RESPONSE TO REQUEST FOR ADDITIONAL INFORMATION

APR1400 Design Certification

RAI No.: 307-7835

SRP Section: 05.04.01 – Reactor Coolant Pumps

Figure 5.4.1-2 Flow Diagram for Reactor Coolant Pump Shaft Seal System

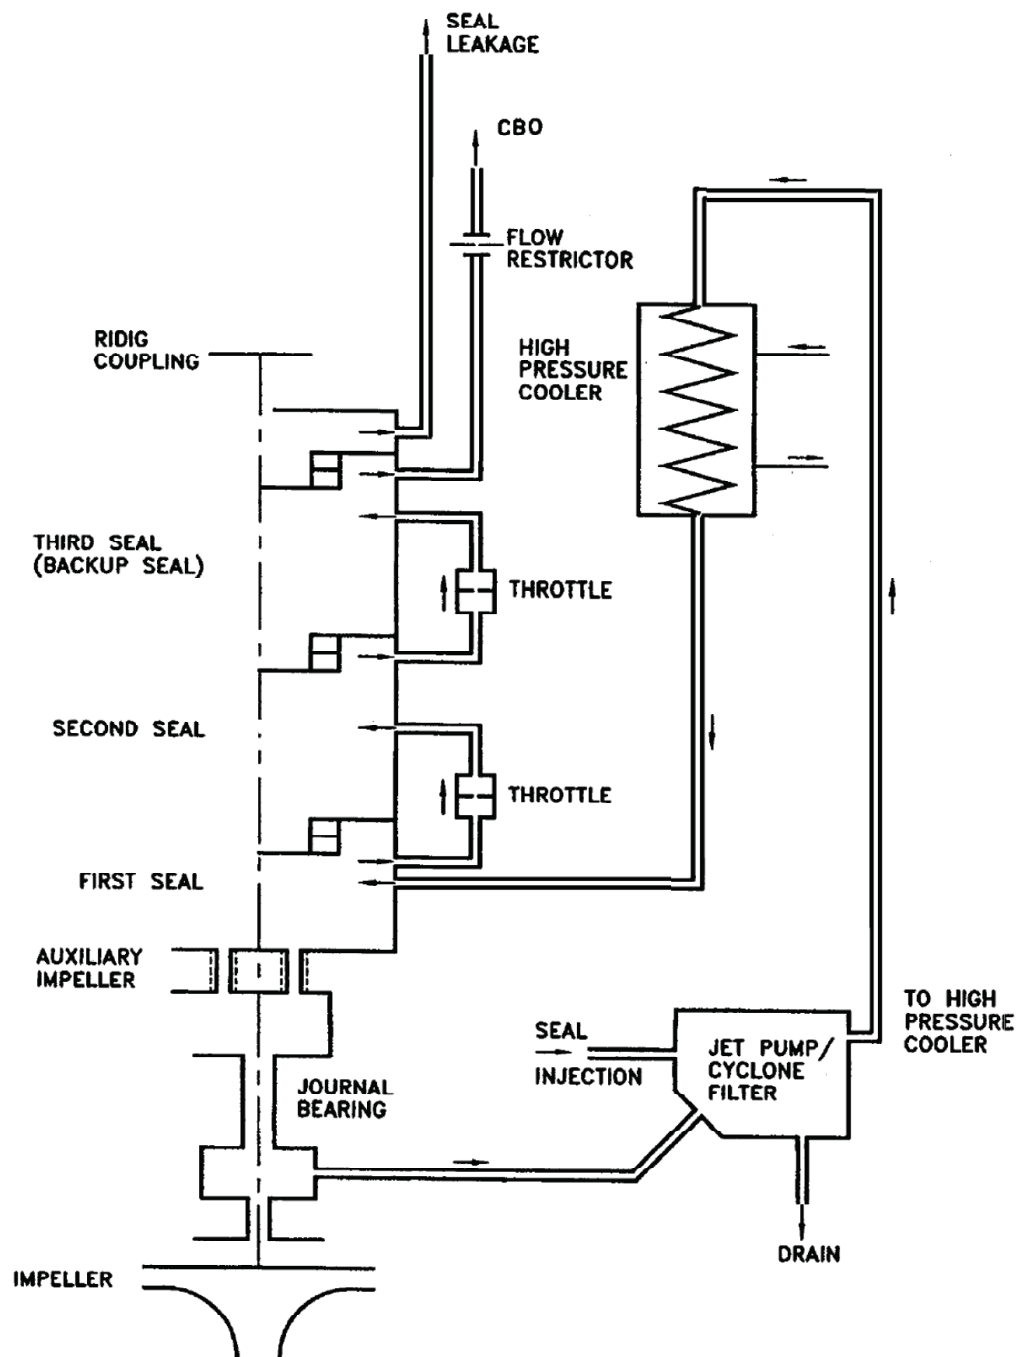
1. DCD Subsection 5.4.1.2 states that "The RCP shaft seals are cooled by (1) seal injection water from the CVCS and (2) the component cooling water (CCW) through a high-pressure seal cooler. Pump seal operation may continue indefinitely provided either seal injection water or the CCW is available. The APR1400 design includes an additional support system (i.e., auxiliary charging pump). This system features a positive displacement pump to provide a diverse means of seal injection to the RCPs if the normal means of seal cooling are lost. Detailed descriptions are given in Subsections 9.2.2.3 and

9.3.4.2.” The staff could not find a detailed description of the seal injection flow paths into and within each of the seal stages in the DCD Subsections 9.2.2.3 and 9.3.4.2. Without such details, the staff could not validate that pump seal operation may continue indefinitely as stated above. At the staff’s request in the non-Chapter 15 audit plan, the applicant presented a non-proprietary document which shows the seal injection flow paths including the existence of an auxiliary impeller, integral to the pump shaft, which provides the driving force for recirculation of seal water through the external high-pressure seal cooler. The applicant is requested to add those details to DCD Subsection 5.4.1 as part of the pump design description.

4. In DCD Figure 5.1.2-2, the staff noted the use of a jet pump in the seal injection line from CVCS. A description of this jet pump and its functional requirements are not provided in DCD Subsection 5.4.1. The applicant is requested to add these details for the jet pump in DCD Subsection 5.4.1.

1. Additional information from those provided for the non-Chapter 15 audit will be included in DCD Subsection 5.4.1.
2. DCD Subsection 9.2.2.5 will be corrected by removing "thermal barrier" to be consistent with 5.4.1.

4. Additional information from those provided for the non-Chapter 15 audit will be included in DCD Subsection 5.4.1.
5. The seal injection flow is provided by one of two charging pumps or an auxiliary charging pump of CVCS as described in DCD Subsections 5.4.1.2, 9.2.2.3, and 9.3.4.2. The auxiliary charging pump provides diverse means of seal injection when the normal means by the charging pump are unavailable. The operation of the auxiliary charging pump is not affected by loss of CCW whereas the charging pump is affected by improper function of the charging pump mini flow heat exchangers due to loss of CCW. If loss of CCW

As indicated in Figure 5.4.1-2, seal injection water enters into the high pressure piping at a point below the water lubricated bearing and is directed through the cyclone filter/jet pump assembly to the high pressure cooler before being injected into seal system. The effluent from the high pressure cooler enters the high pressure side of the first seal and is divided into two flow paths. A majority of the flow is pumped through the journal bearing by the auxiliary impeller. This cools the journal bearing and minimizes the ingress of contaminants into the seal system. The second flow path is into the first seal and through a throttle coil to the high pressure side of the second seal. Flow from the second seal continues through another throttle coil to the third seal and then to the volume control tank within the chemical and volume control system. The controlled leakage around the seals is required for seal pressure distribution. Should injection water fail, controlled bypass leakage comes from the pump casing and passes through the high pressure cooler by natural circulation. As described above, a portion of this water is circulated by the auxiliary impeller through the journal bearing, high pressure cooler and back to the seal area.
